| Intersection ID: 44786 | Main Street: AYRSLEY_TOWN_BV | Cross Street: KINGS_PARADE_BV | Location: | SW |
| ADA ID: CABCFE756938 | Ramp Type: Perp | Initial Pass/Fail: Fail | Overall Compliance: No | Severity Score: 12.5 |

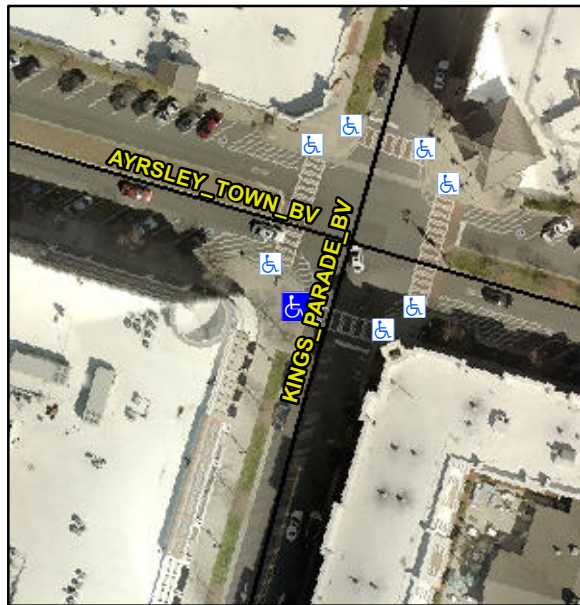
Not Found, R304.2.2

| Compliance | Description | Data | Compliance | Description | Data |
|------------|-----------------------|-------|------------|-----------------------------|------|
| N/A | Ramp Length (in) | 60.0 | No | Ramp Slope (%) | 11.9 |

Remove & Replace Entire Ramp.
